DEVIATION REVIEW AND DECISION FORM

Subdivision or Project Name: Springs at Waterview

Section of ECM from Which Deviation is Sought: 2.2.5.D.1

Proposed Nature and Extent of Deviation: Request for interim three-quarter movement (left-in/right-in/right-out) access point to Bradley Road approximately 505 east of Grinnell Boulevard (centerline spacing) to provide a second access to the proposed residential development north of Bradley Road. The Collector classification of Bradley Road in this location is per the approved Sketch Plan. The three quarter access is labeled as "interim" because the applicant is agreeable to the access being restricted in the future to right-in/right-out if Bradley Road is connected between Powers and Goldfield Drive.

Option A: Connection to Bradley Road; Plan View

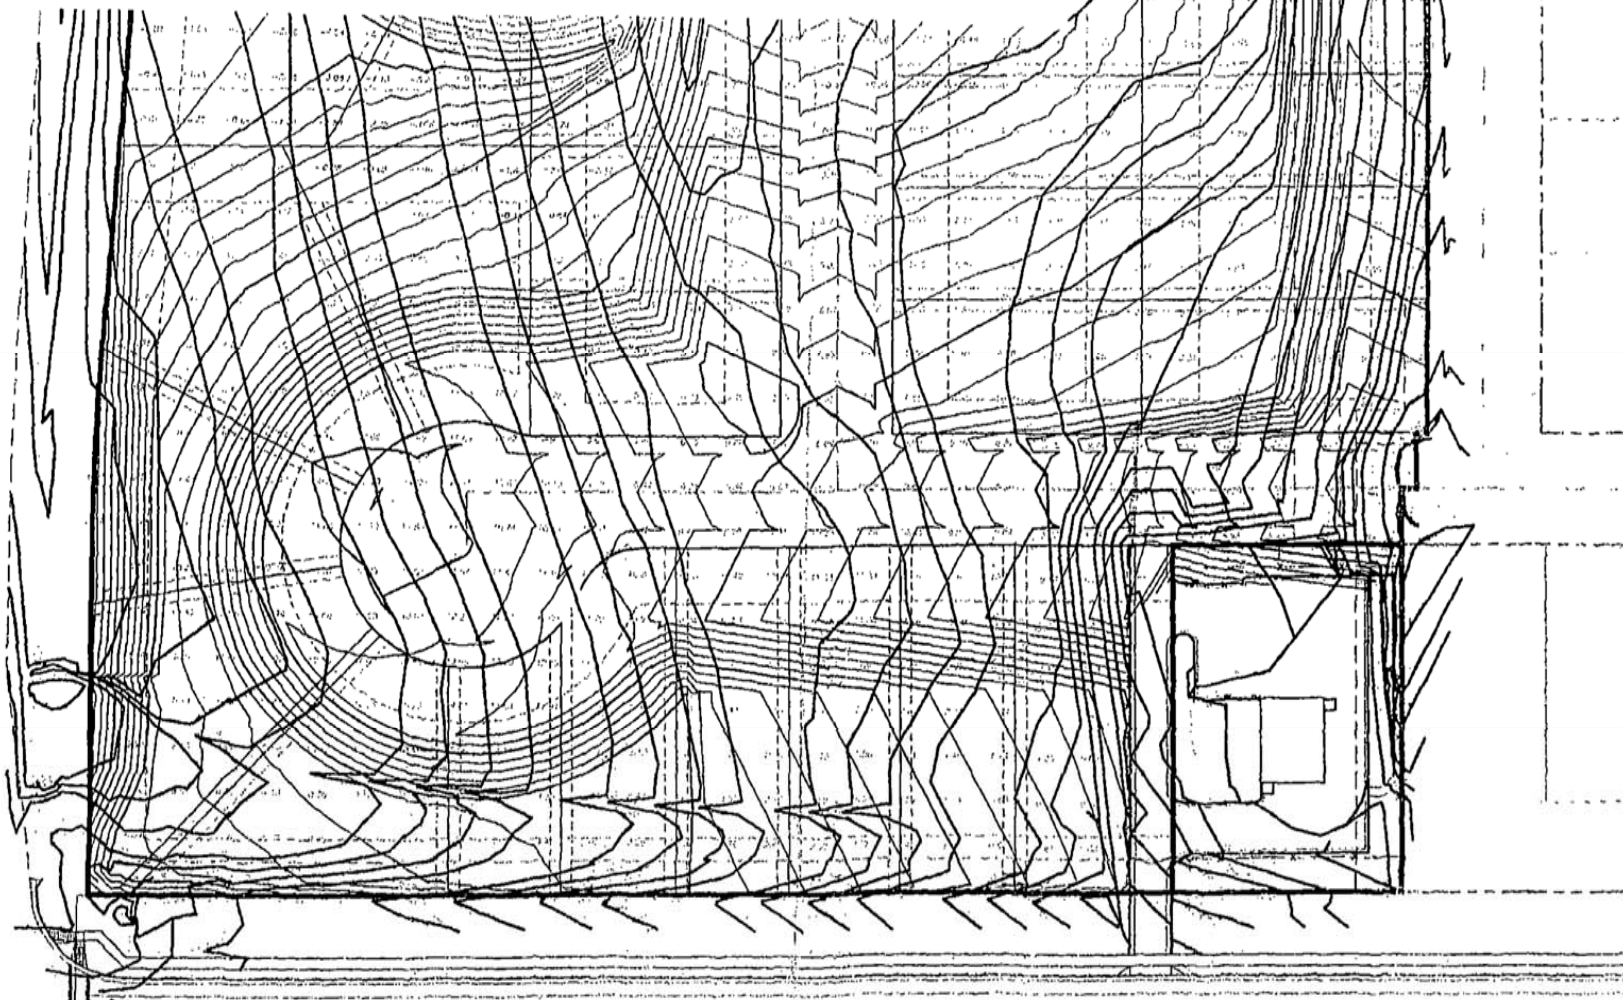
Reason for the Requested Deviation: The deviation is requested to provide a second point of access to the proposed residential development to be located east of Grinnell Boulevard, south of Goldfield Drive, west of Escanaba Drive and north of Bradley Road. The primary access would be to Escanaba Drive near the north end of the site. The deviation is requested as the required grading to provide a secondary access to Escanaba at the south end of the site would be cost-prohibitive and an undue hardship to the applicant. The estimated additional cost associated with a second access to Escanaba versus a second access to Bradley Road would be \$400,000 to \$500,000. Please refer to attached Exhibits A and B.

The cost of required site grading to provide a secondary access to Escanaba at the south end of the site would be cost-prohibitive and an undue hardship to the applicant. The estimated additional cost associated with a second access to Escanaba versus a second access to Bradley Road would be \$400,000 to \$500,000. Please refer to attached Exhibits A and B.

X CONDITION OF DEVIATION APPROVAL:
3/4 ACCESS MAY BE FURTHER RESTRICTED IF BRADLEY ROAD
IS CONNECTED BETWEEN POWERS BLVD & GOLDFIELD DRIVE OR AS
DETERMINED BY THE COUNTY ENGINEER.
____ Additional comments or information are attached.

Option B: Connection to Escanaba (If Bradley Road Deviation is not approved);
Plan View

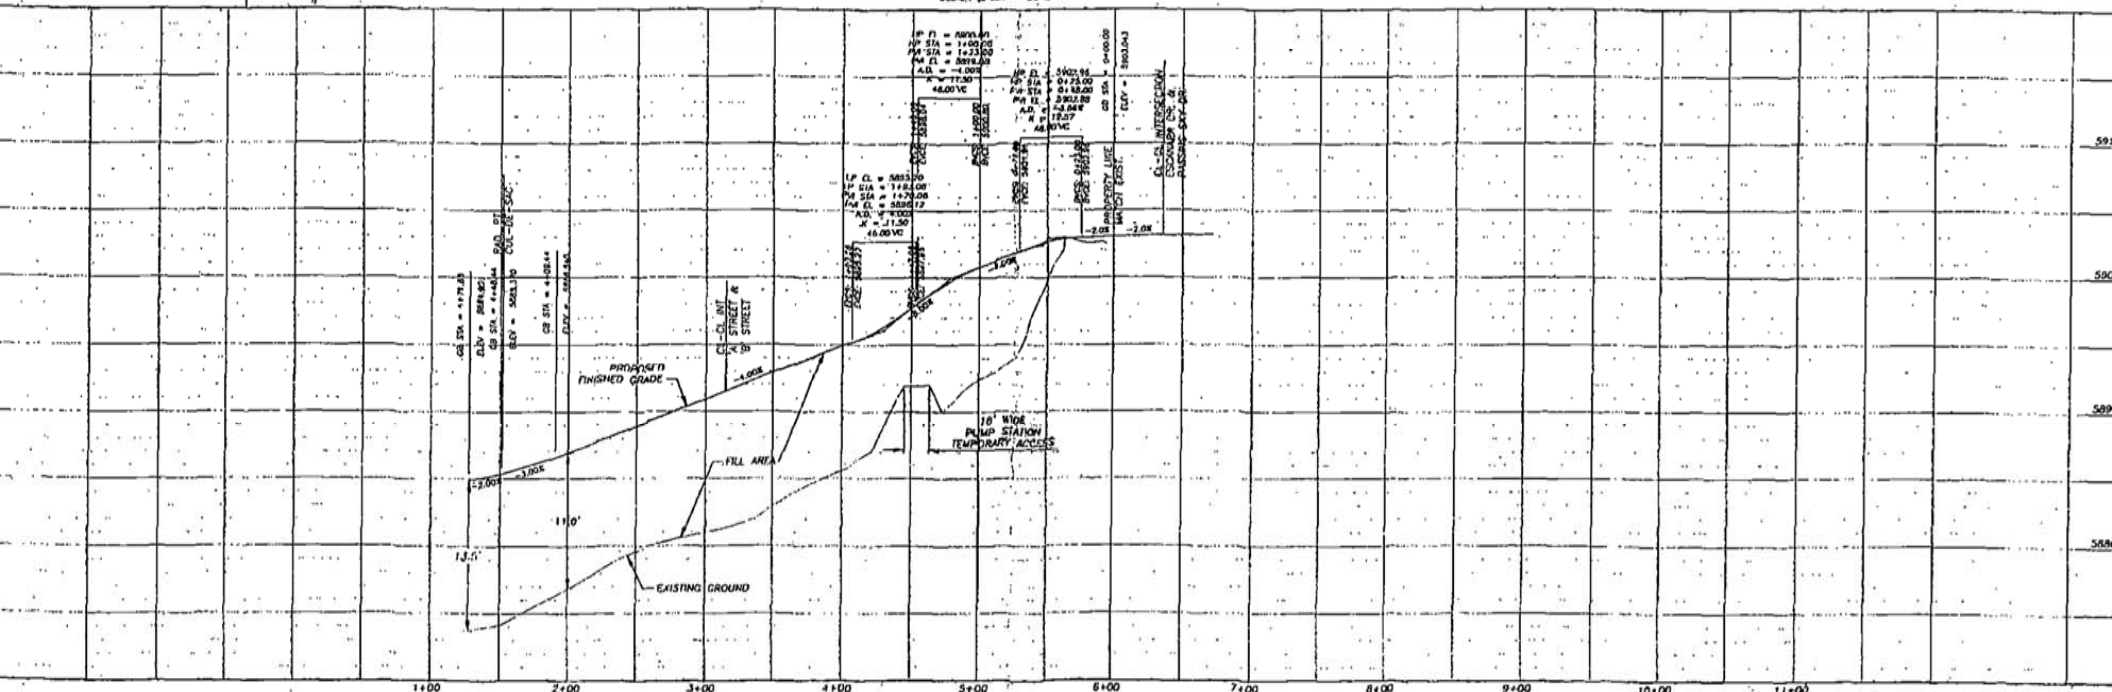
Additional "cut" on property of 39,000 yards

Additional Import of 32,000 yards.
